Thank you for the opportunity to serve on the I-90 Task Force. As the former Mayor of the City of Cambridge and a long-time Cambridgeport resident, I'm pleased to work with DOT on this important project, to serve as a liaison between MassDOT and the Cambridge community.

2. ACCESS TO CAMBRIDGE FROM SOLDIERS FIELD ROAD: DOT SHOULD STUDY 3 OPTIONS (SKETCH PLANS OF TWO ADDITIONAL OPTIONS ATTACHED) AND DEFER EXIT RAMP DECISION

ATTACHMENT A NEW RIGHT-TURN EXIT RAMP

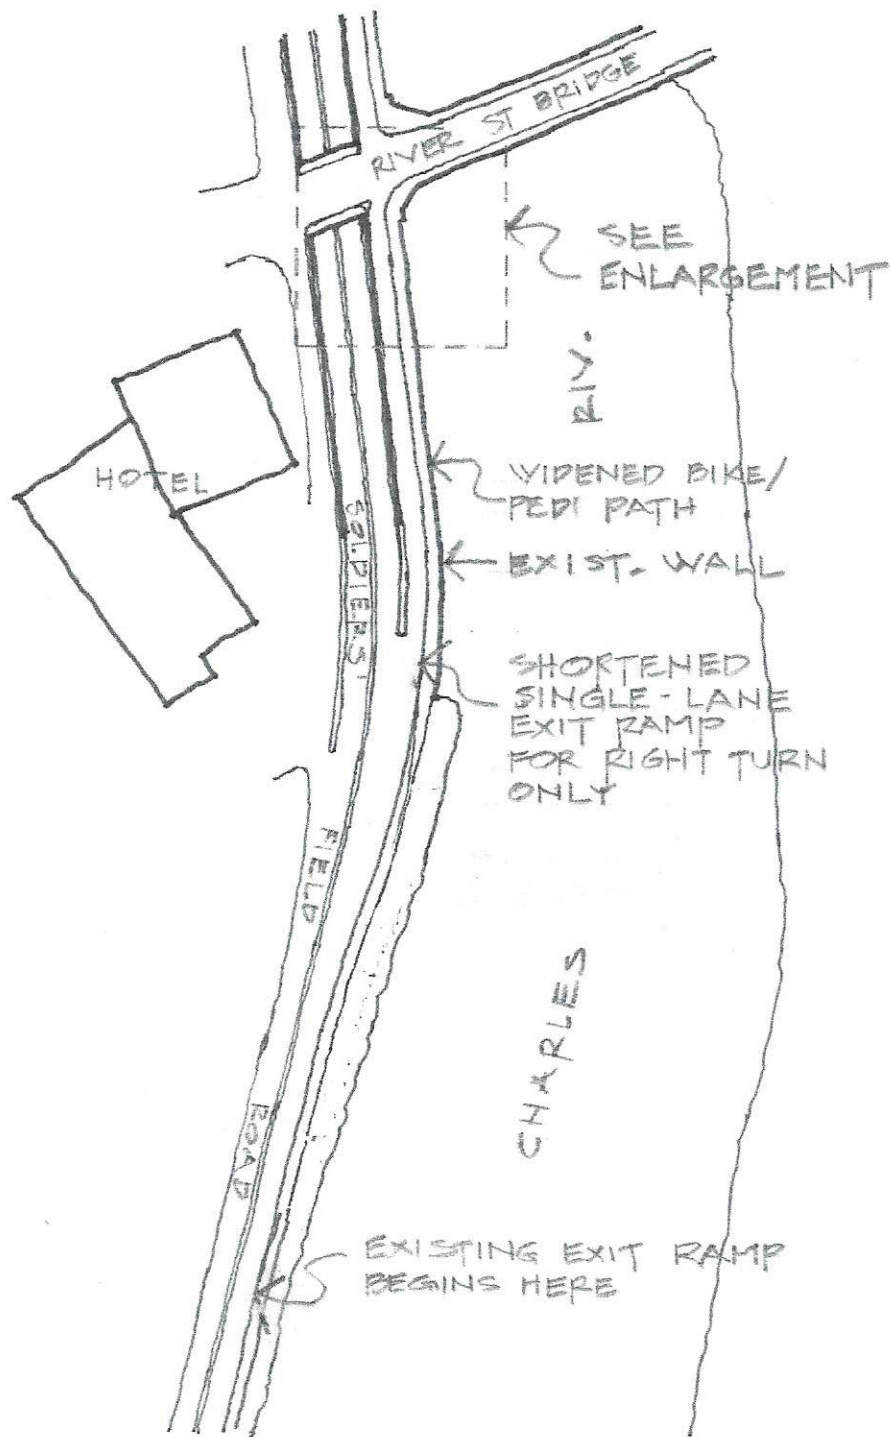
- Current DOT plan that eliminates the exit ramp from Soldiers Field.
- A new option would include the shortest possible exit ramp with a right-turn only to River Street into Cambridge (sketch plans attached).
- A second new option that extends the underpass for Soldiers Field Road from the new Cambridge Street South in Allston (in the current DOT plans) to the existing underpass under River Street in a continuous cut-and-cover, providing for a narrow surface road and expanded park on the decking over Soldiers Field Road (sketch plans and renderings attached).

RIVER ST EXIT
RIGHT TURN
ACCOMMODATION STUDY

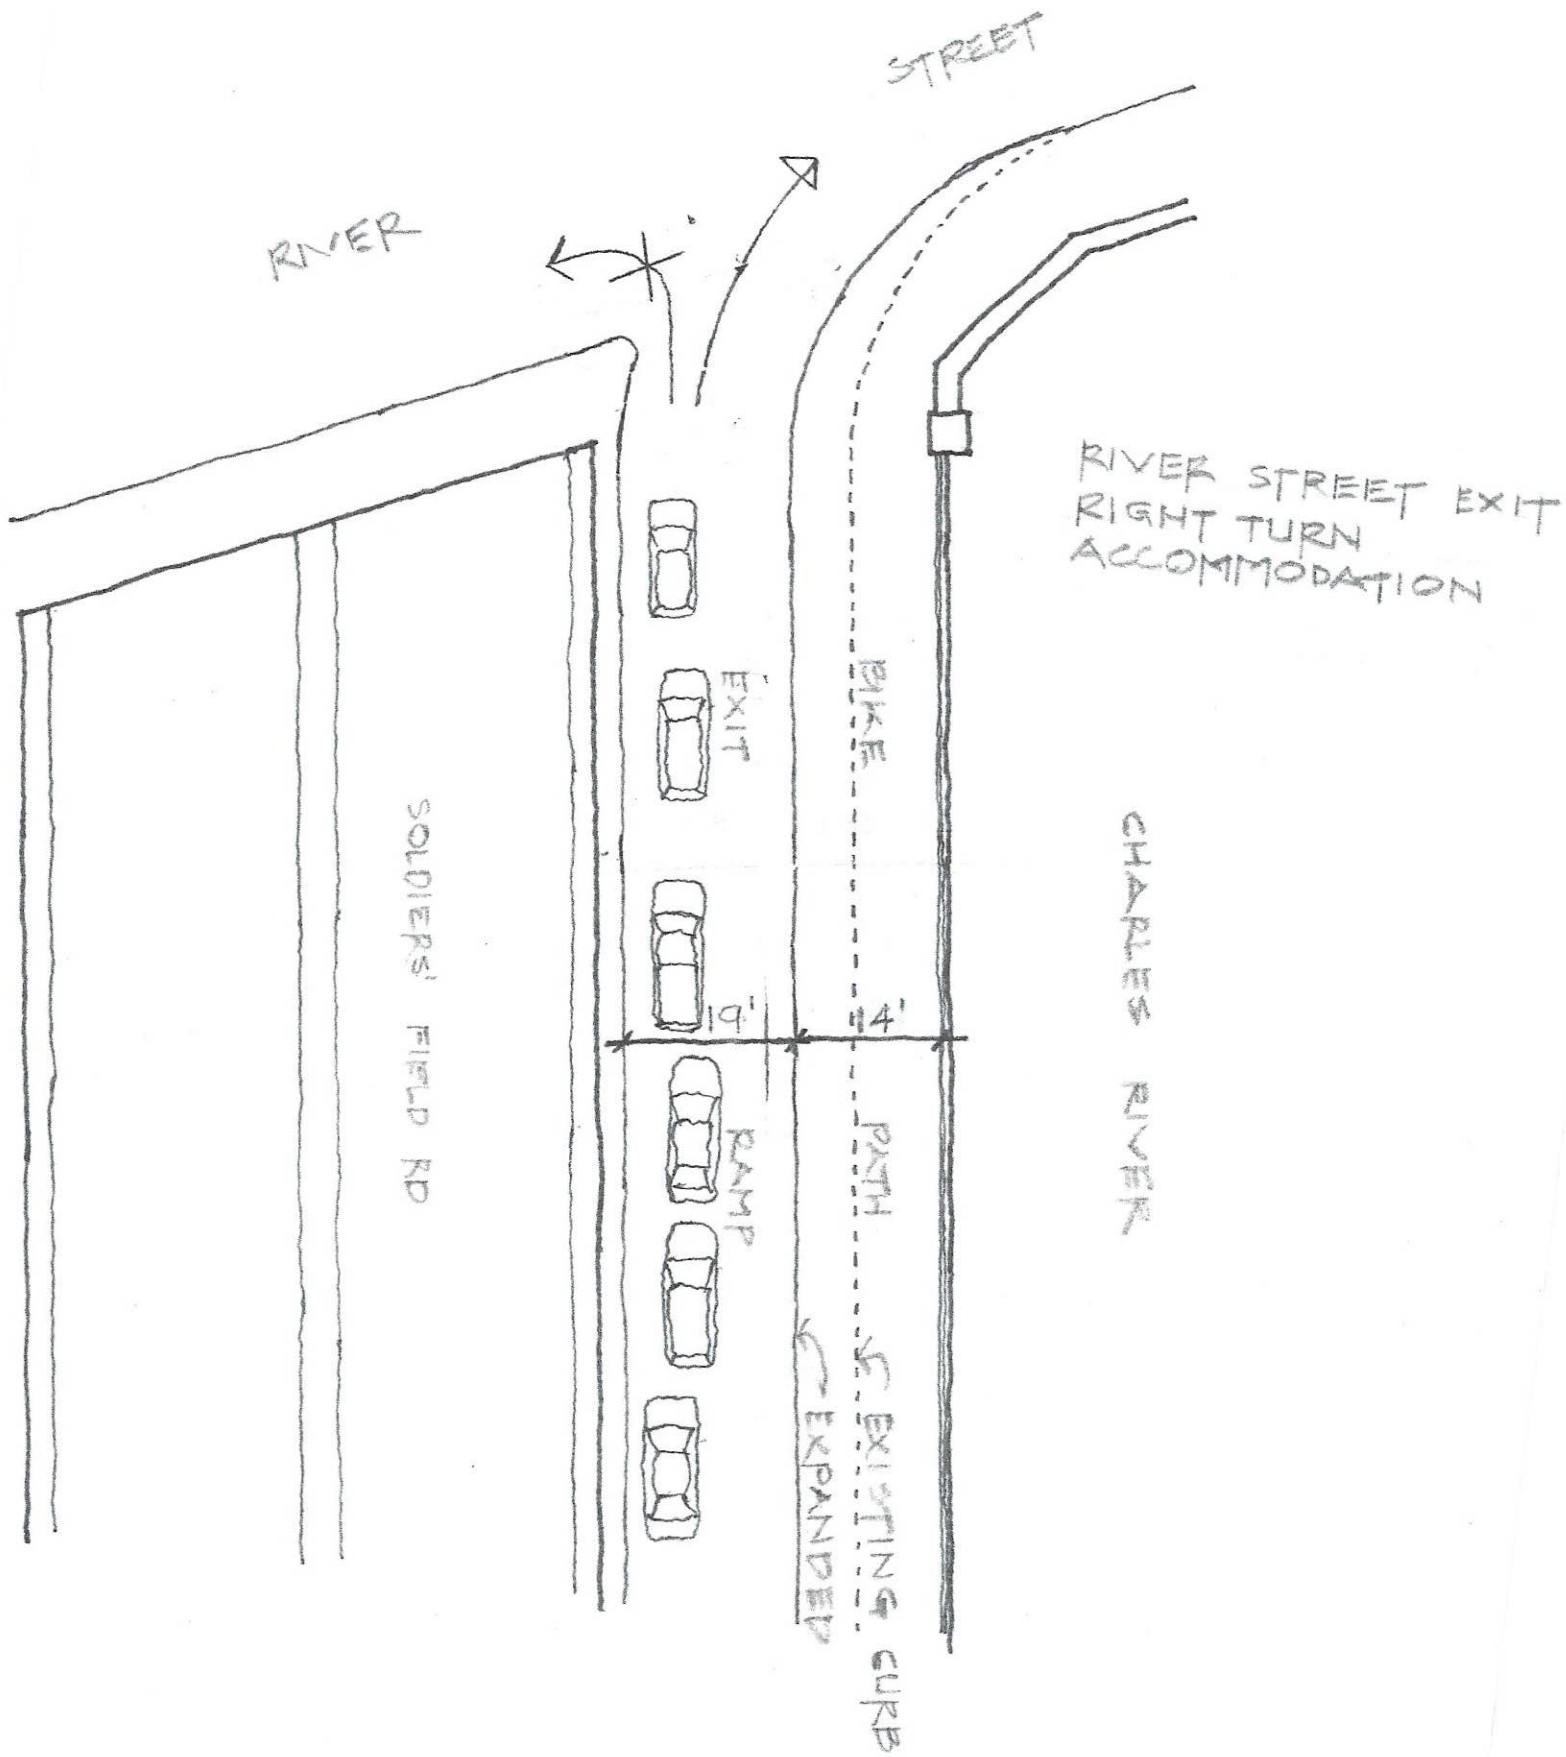
1. BETTER ACCESS FROM SOLDIERS FIELD RD TO RIVER ST BRIDGE
2. CONNECT KEY PARCELS AND PARKLAND
3. MORE PARKLAND
4. REDUCE ROAD NOISE IMPACTS ON PARKLAND

NEW 2 LANE SURFACE ROAD OVER 1/2 OF CUT & COVERED SOLDIERS FIELD ROAD

RIGHT TURN FROM SURFACE ROAD TO RIVER ST BRIDGE

30' WIDE ADDITIONAL NEW PARKLAND OVER 1/2 OF COVERED SOLDIERS FIELD ROAD

NEW PROPOSAL TWO UNDERPASSES + 1600' ADDITIONAL DECKING

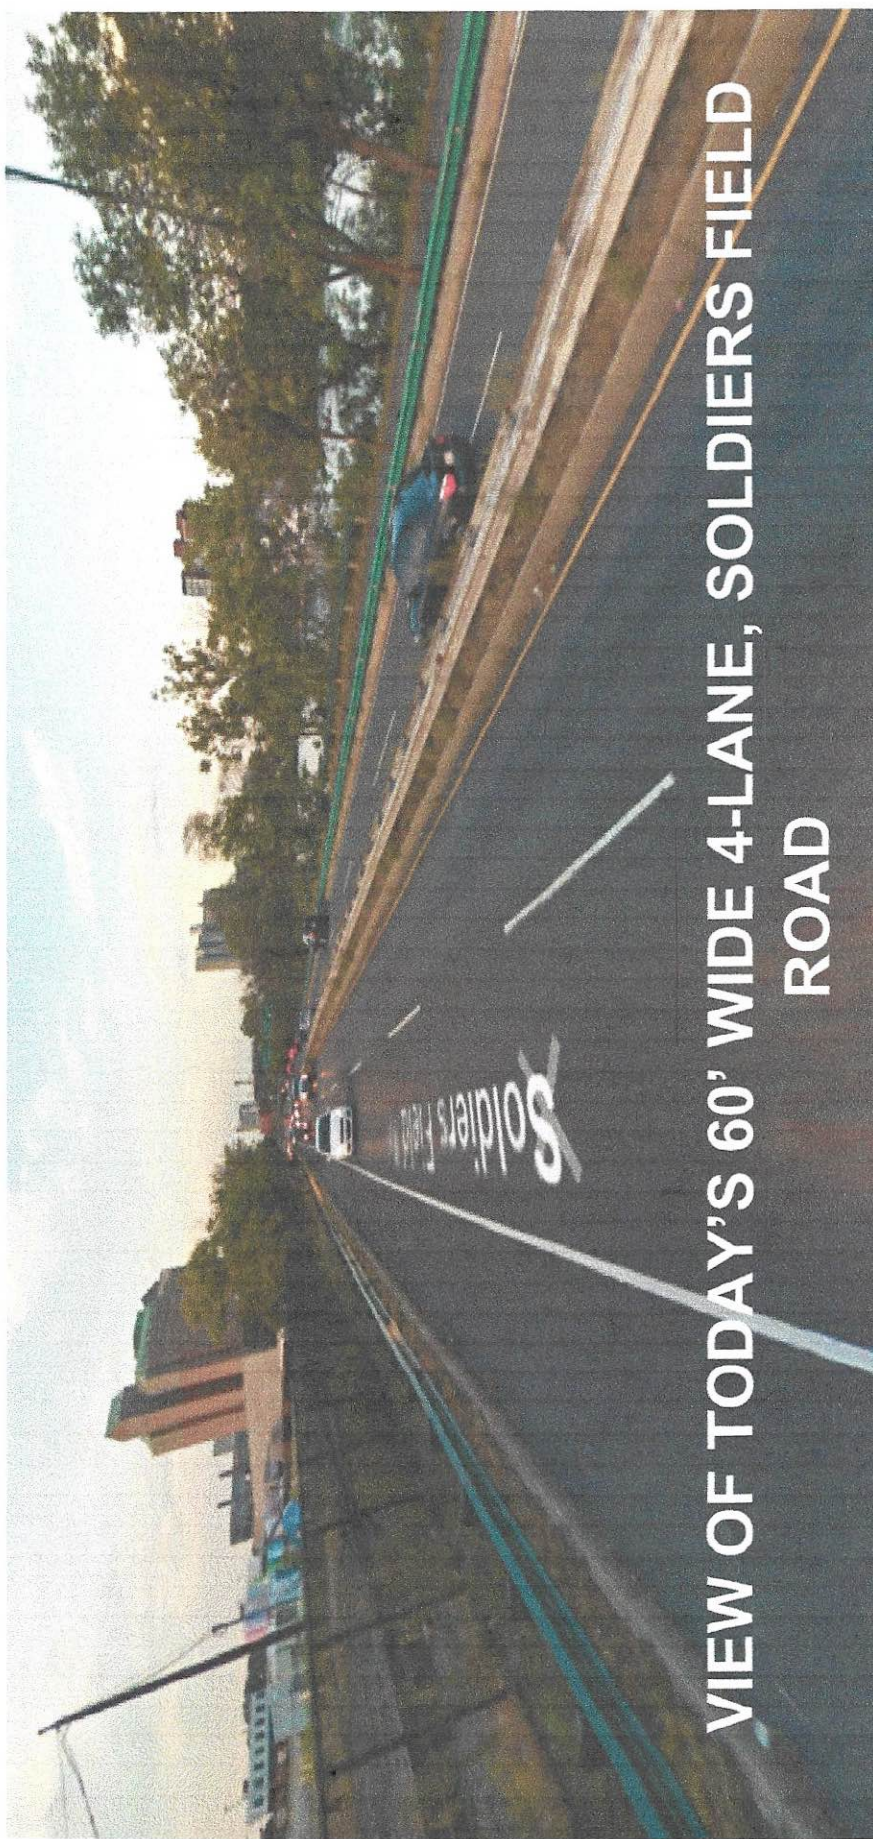
SFR in tunnel with decking
above to create at-grade
crossing to river park

THREE UNDERPASSES (CURRENT MASSDOT PROPOSAL)
